**YARRA CITY COUNCIL**  
**Internal Development Approvals Committee**  
**Agenda**

**to be held on Wednesday 2 May 2018 at 6.30pm  
in Meeting Rooms 1 & 2 at the Richmond Town Hall**

**1.1 11 Brunswick Street, Fitzroy - PLN17/0694 - Development of the land for the construction of an 8 storey building at the rear of the site, including a reduction in the car parking requirement and partial demolition of the existing dwelling.**

Figure 12 – Proposed footpath on ROW

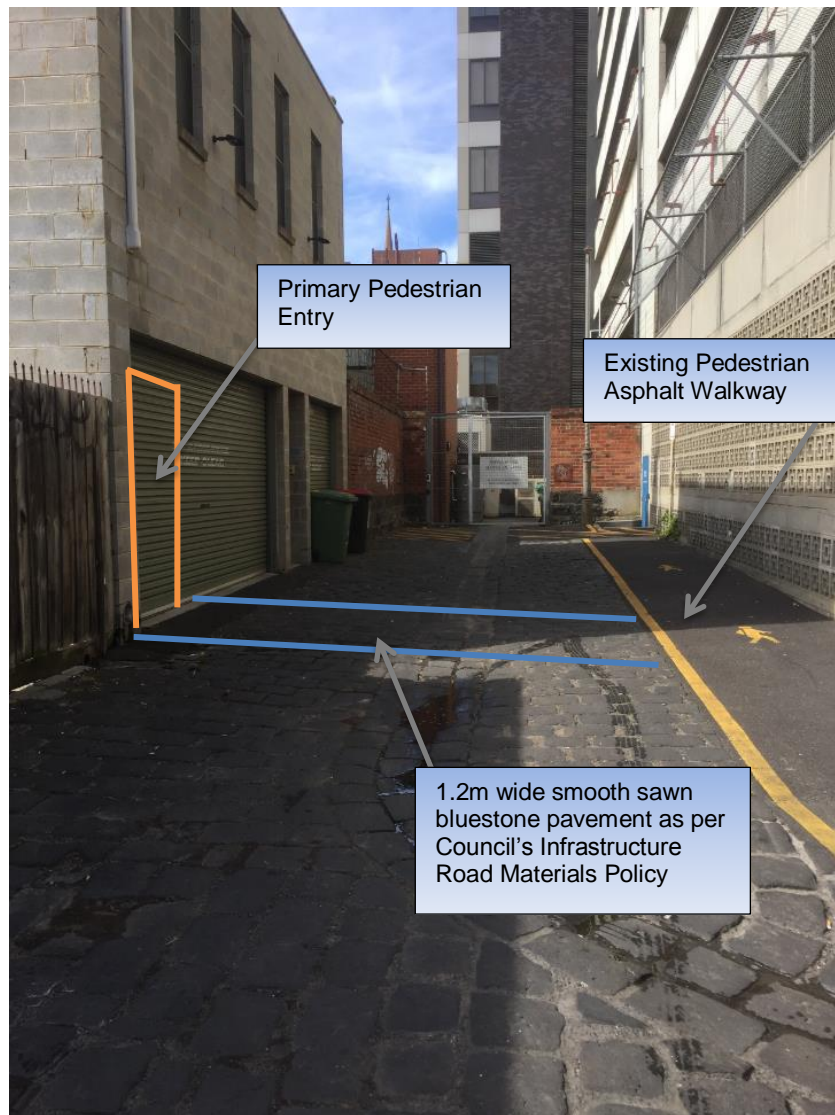
- 197. To further improve the link between the rear entrance and the existing asphalt walkway along the western side of the ROW, it is considered reasonable for the Applicant to construct a 1.2m to 1.8m wide smooth bluestone pavement as shown on Figure 12. This can be required via a condition of the permit, if one is to issue.

Diagram 1

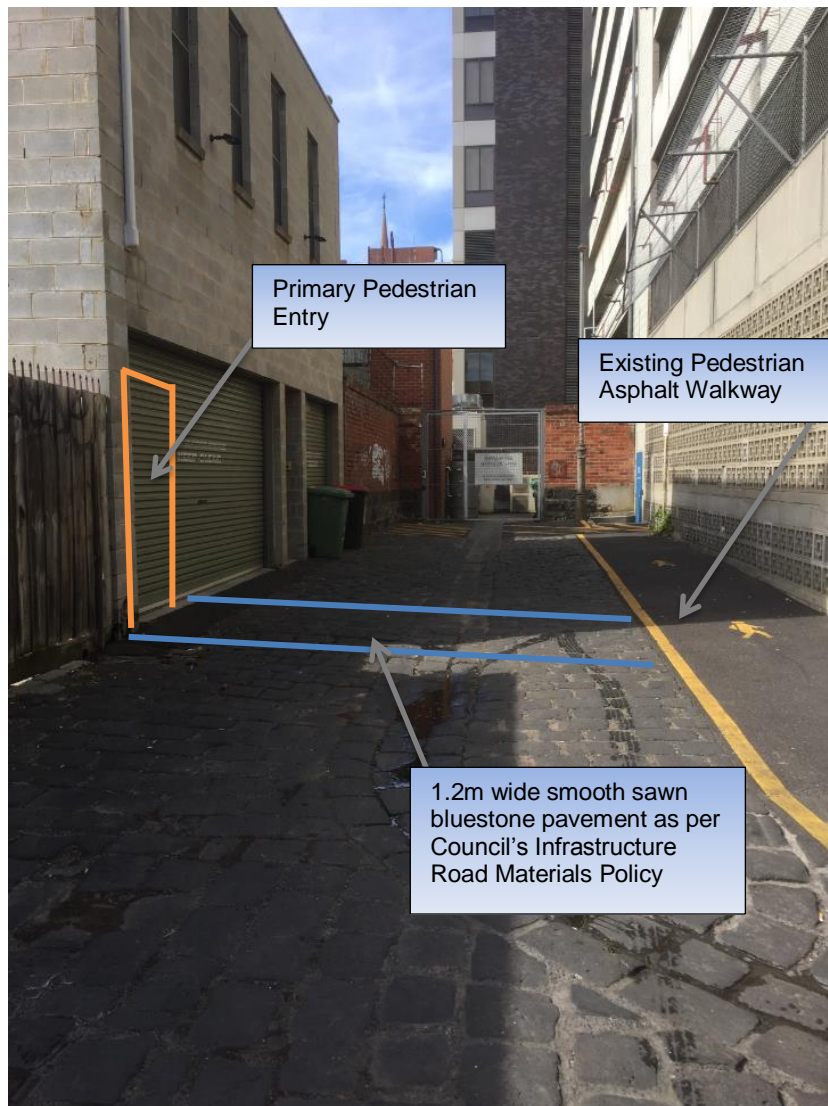
### Car Stacker Device
